Anglia Square,
Norwich
Transport RevC Note

To: **Norwich City Council / Norfolk County Council**
From: **Iceni Projects (Transportation)**
Date: **January 2023**
Title: **Anglia Square, Norwich – Revision C Note**

3. Following on from the July 2022 Transport Assessment Addendum (RevA) submission, further amendments have been made to the proposed development as the scheme has evolved through consultation, which will be submitted as part of a Revision C submission. This note outlines the new proposals and how it compares to the previous Transport Assessment Addendum (RevA).

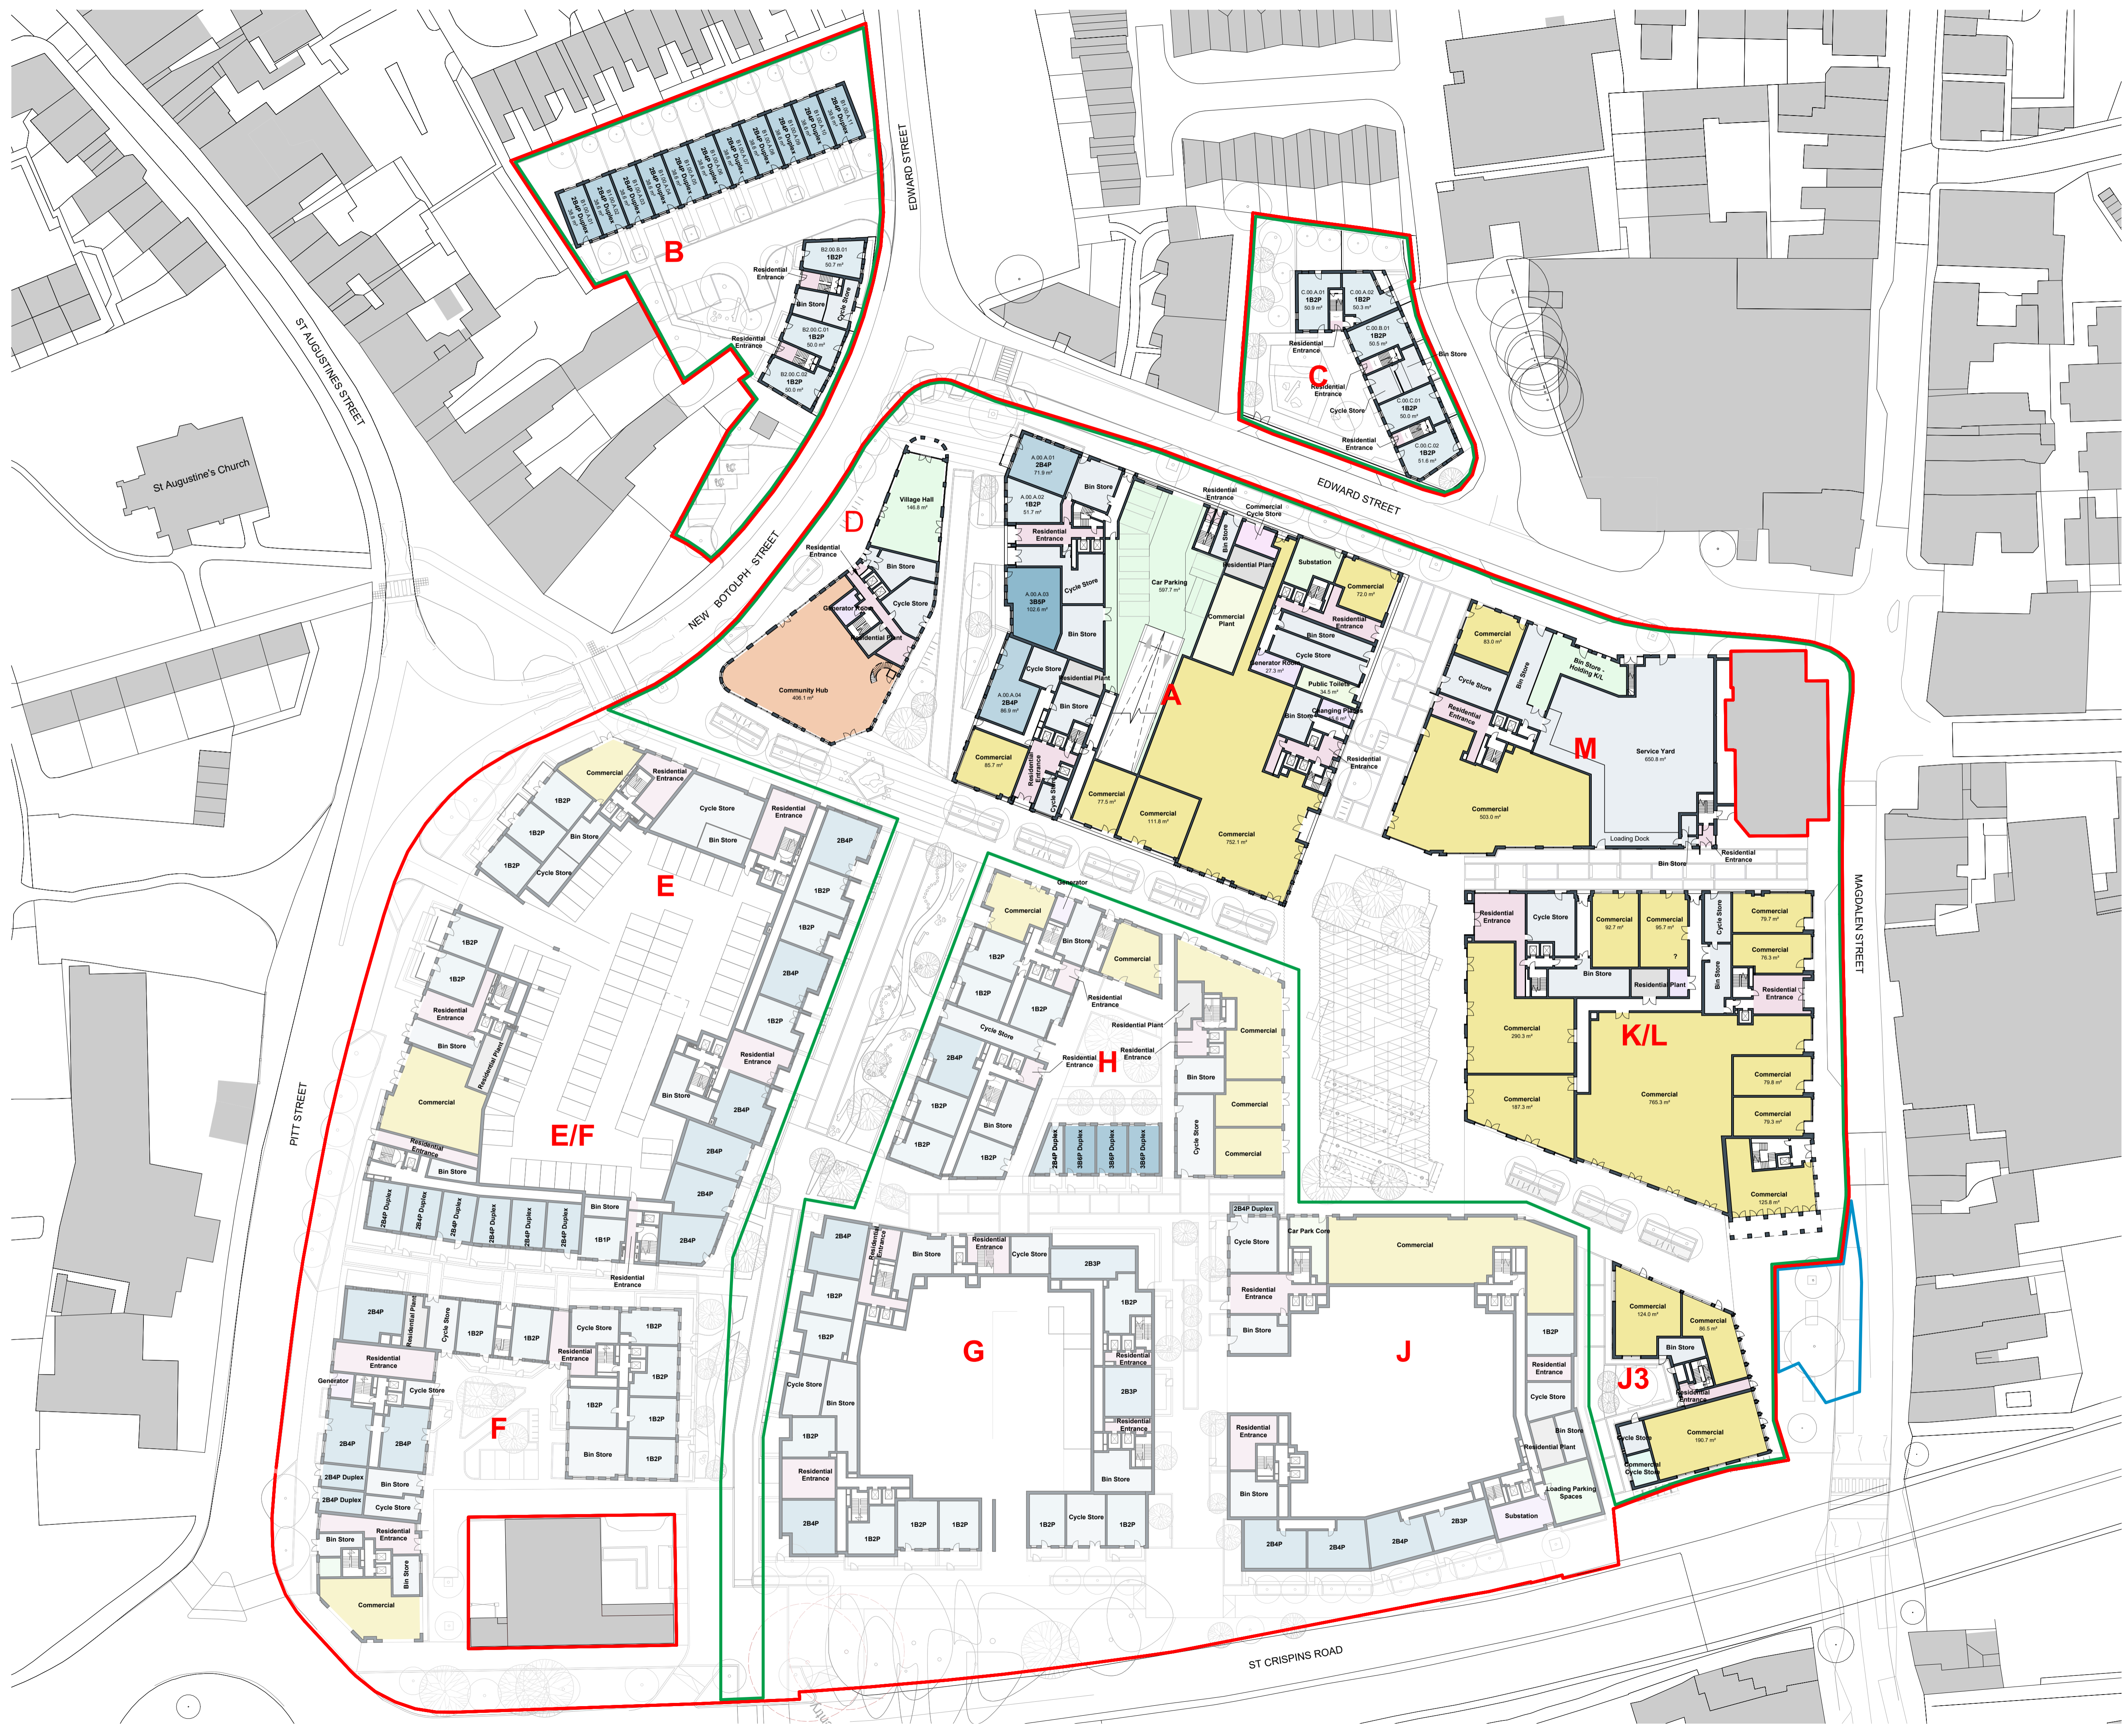
14. Since the originally submitted TA and further TA addendum, there have been ongoing discussions with Norwich City Council and Norfolk County Council to determine the proposals for the mobility hub. The proposals shown in the previous transport reports will be the subject to a planning condition on the hybrid application.
15. The latest agreed proposals which are similar to the works in the original TA can be found in **Appendix A3**.

SITE LAYOUT REVIEW - LANDSCAPING

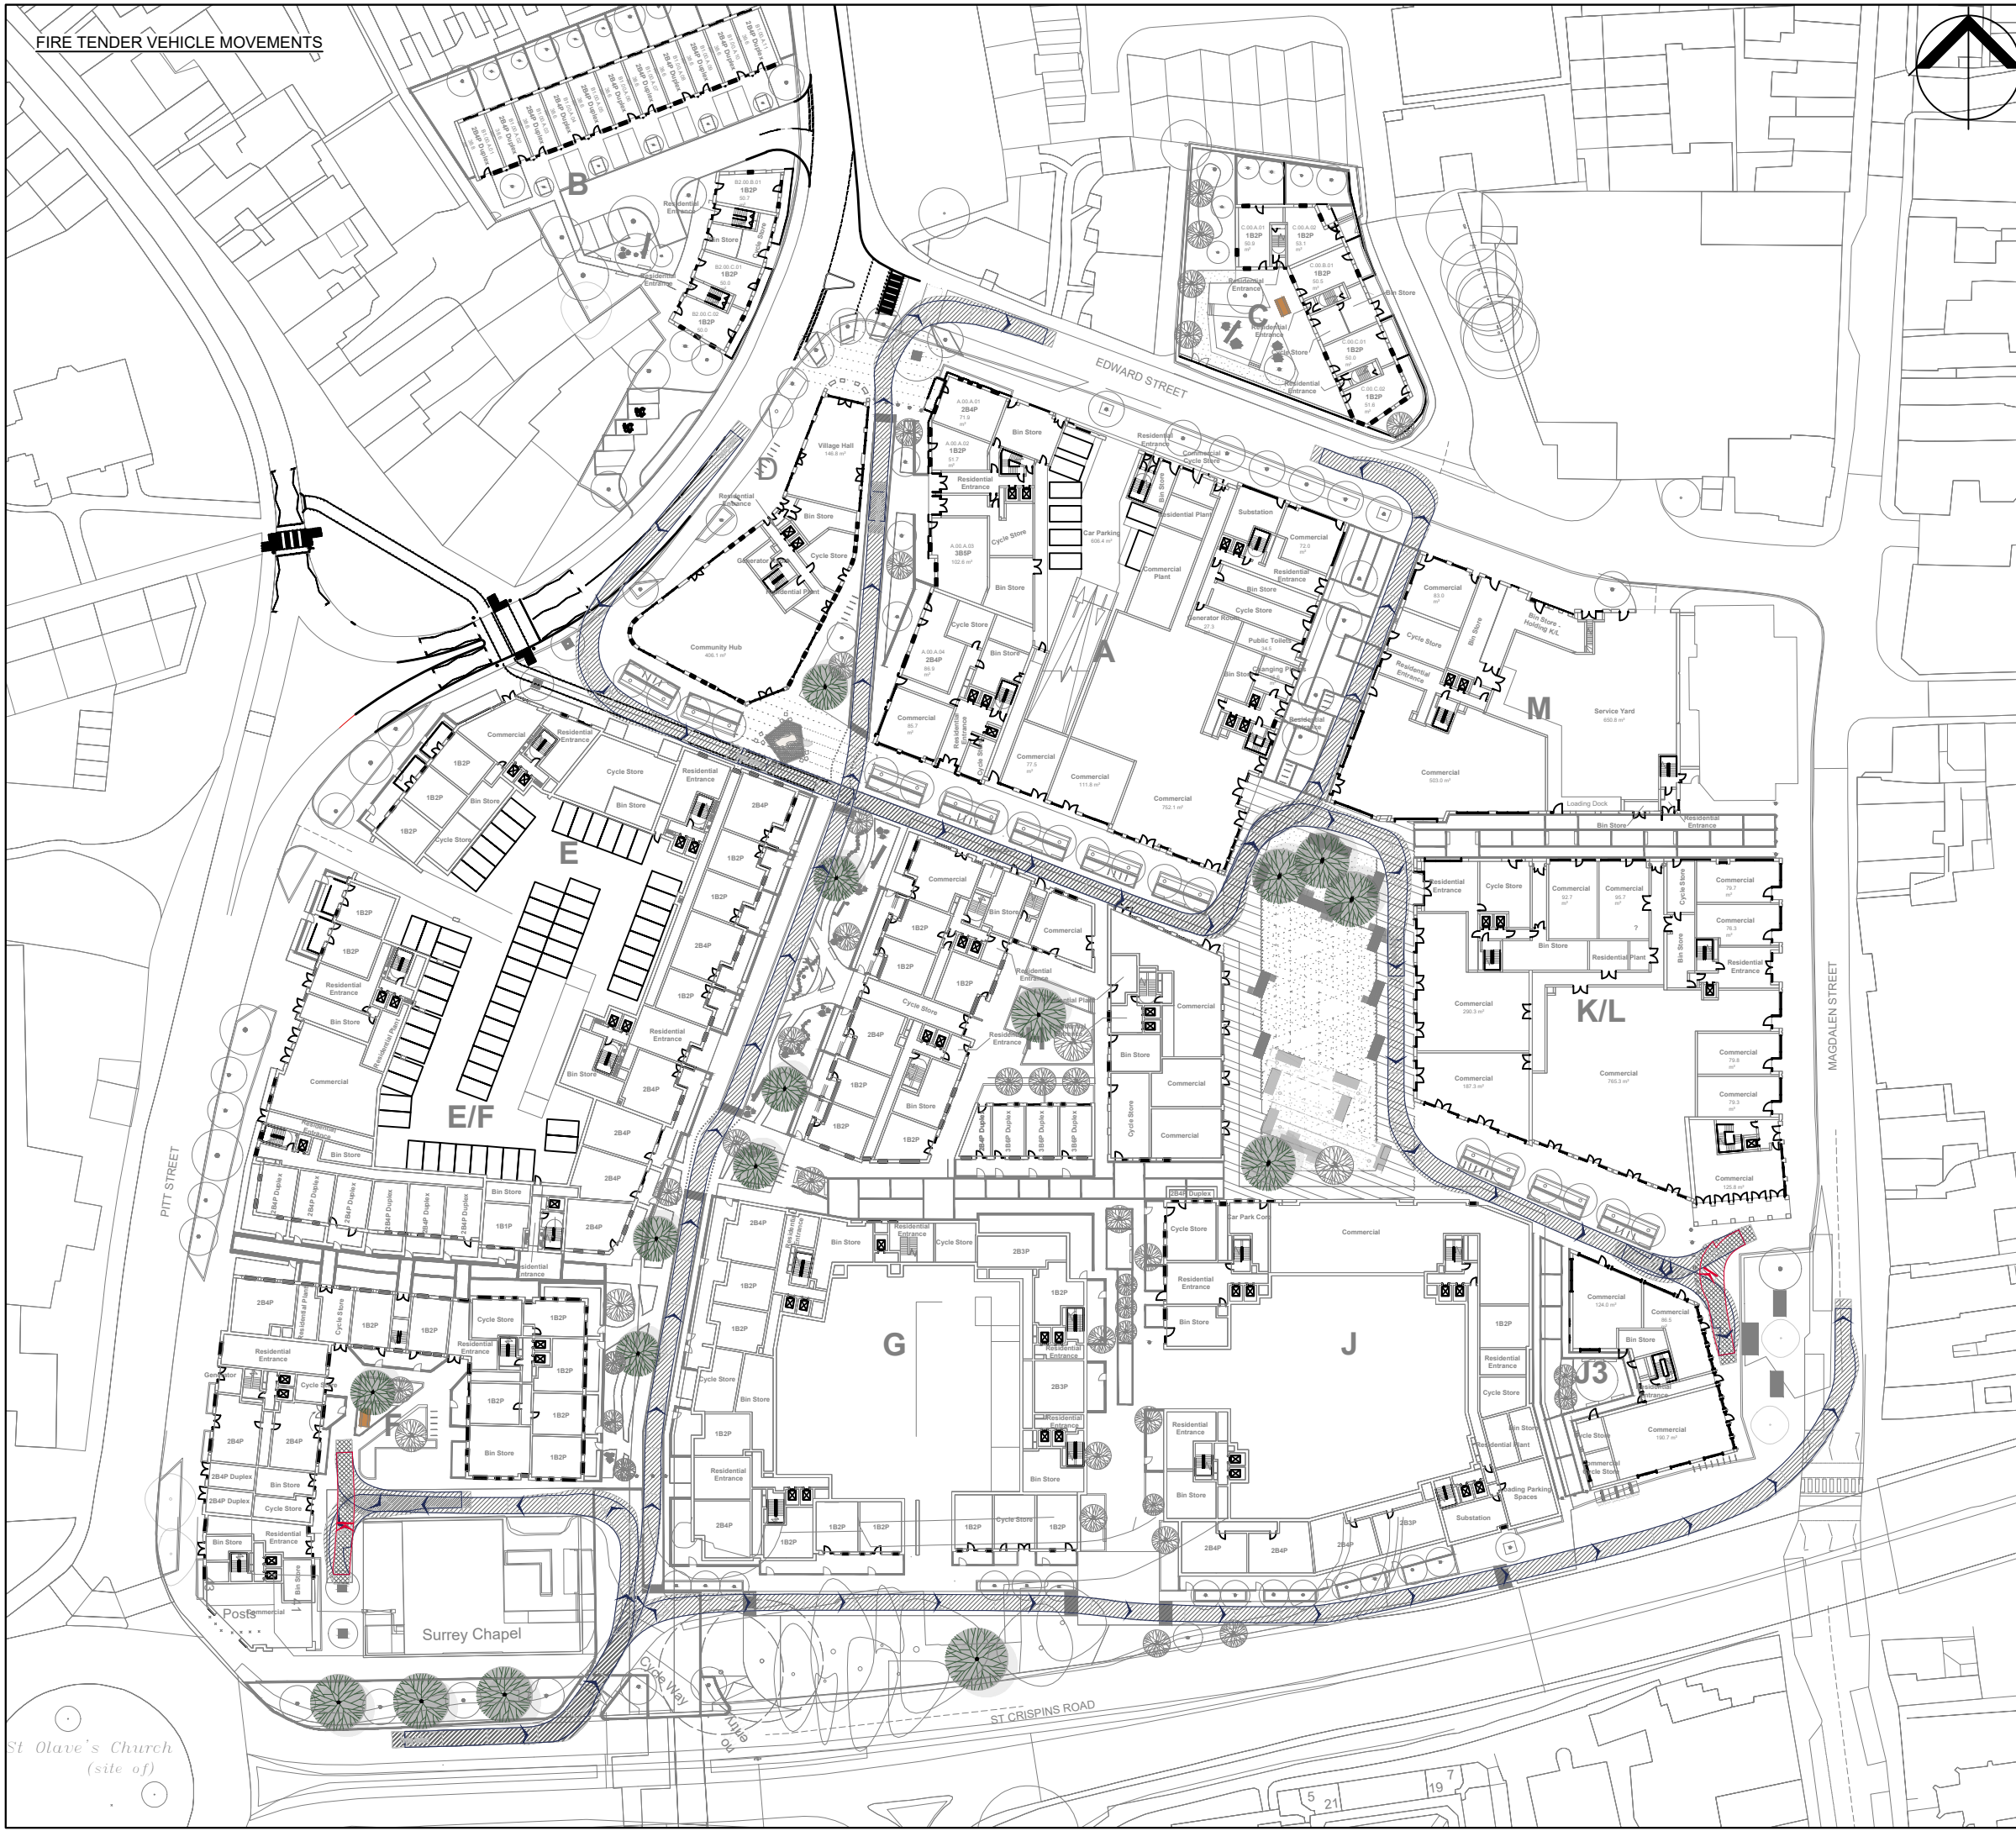
<p>None</p> <p>21-T123_41.1A</p> <p>21-T123_41.2A</p>	<p>21-T123_32G</p> <p>21-T123_45A</p> <p>21-T123_46A</p>	<p>In order to ensure that the development proposals allow for all vehicle movements. Further iterations to the previous tracking proposals have been produced. These drawings show car, refuse vehicle, and fire tender vehicle movements throughout the site.</p> <p>The tracking drawings show that the area provided for vehicle movements is sufficient and does not impact on the surrounding landscaping/building edge detailing.</p>	<p>These changes are all minor amendments and are not considered as a material change to the planning application.</p>
